MEMORANDUM FOR: Victor Stello, Jr., Director, TMI Operations  
FROM: Don Davis, Duty Officer Shift B  
SUBJECT: RESPONSE TO REQUEST FOR HEADQUARTERS ADVICE  
ON COOLDOWN

ADVISORY REPORT

REACTOR SYSTEM COOLDOWN

TMI-2

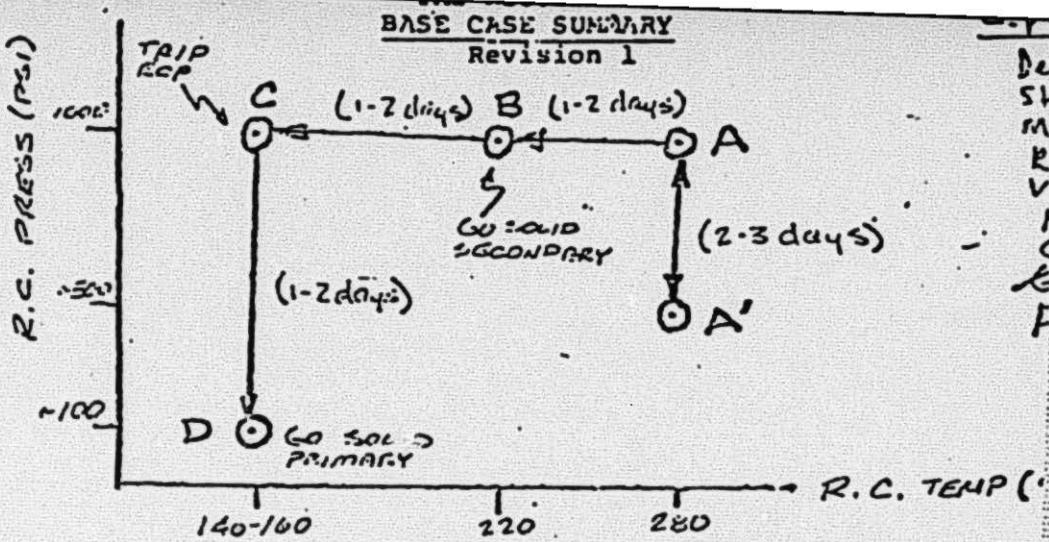
The purpose of this report is to summarize the recommendations of the HQ Technical Support Teams with respect to the cooldown of the reactor system. In particular, that phase of cooling down the reactor system from a temperature condition of about 280°F, to a temperature of 150°F at a coolant pressure of about 1000 psi (see attached figure).

- (1) Degas at A; Lower Pressure ( $A \rightarrow A'$ ) while degassing, then return to A.
  - (2) Continue Design/Installation of static and active systems for primary makeup/pressure control and secondary cooling system for "B" S/G.
  - (3) Reduce temperature ( $A \rightarrow B$ ) by steaming on "A" S/G
  - (4) Take "A" S/G solid - drop primary temp. to minimum ( $B \rightarrow C$ )
  - (5) Trip RC Pump "A" - Establish natural convection - Establish cooling to "B" S/G if available.
  - (6) Drop primary pressure to selected value ( $C \rightarrow D$ )
  - (7) Take primary system solid - Control pressure & makeup with static or new active system

MINIMUM ALLOWABLE CONTAINMENT PRESSURE vs BWST-H<sub>2</sub>O  
DESIGN PRESSURE = 125 PSIA

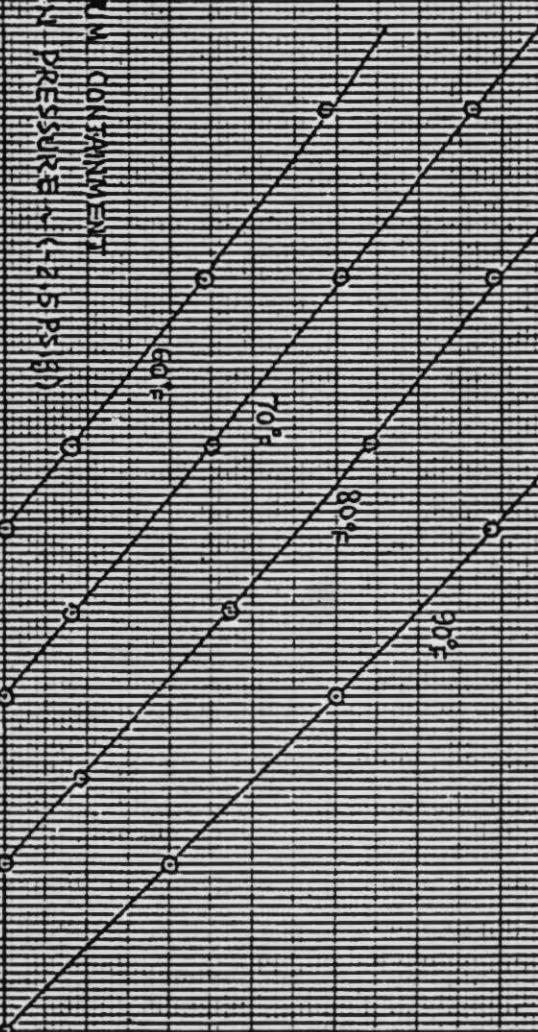
The containment internal pressure has been slightly lower than ambient pressure for most of the time since the accident. At the present time, the containment is at approximately a 0.9 psi reverse pressure differential. Since the design pressure is 2.5 psi, the current pressure is not of immediate concern. Current operating procedures indicate that the water flow to the fan coolers should be terminated if the reverse pressure differential reaches 2.0 psi. This action would effectively terminate further cooldown of the containment atmosphere thereby terminating the transient. In any case, this would be a rather slow transient allowing sufficient time for proper action. We believe, however, a more severe transient should also be considered. This transient is the inadvertent operation of the containment sprays. Initiation of the sprays would result in rapid cooling of the containment atmosphere causing a corresponding rapid decrease in containment pressure. The magnitude of the pressure decrease will depend upon the inlet spray water temperature (BWST water temperature). To assure that the containment does not exceed the design reverse differential pressure of 2.5 psi, the containment parameters should be maintained above minimum values as shown in the enclosed figure. The figure indicates that for a given inlet spray water temperature, the containment temperature as well as containment pressure should be maintained above minimum values. The pressure could be controlled by the addition of a noncondensable gas such as nitrogen or dry air. This procedure has apparently been followed previously to decrease the reverse differential pressure to below 1 psi. Control of containment

temperature could also be achieved by terminating the water to the fan coolers. Since the fan operation would continue, proper mixing of the atmosphere would be maintained while eliminating the heat removal mechanism. Since the consequences of exceeding the reverse design pressure differential is unknown, we believe it prudent to maintain containment conditions as indicated above to allow for inadvertent spray operation
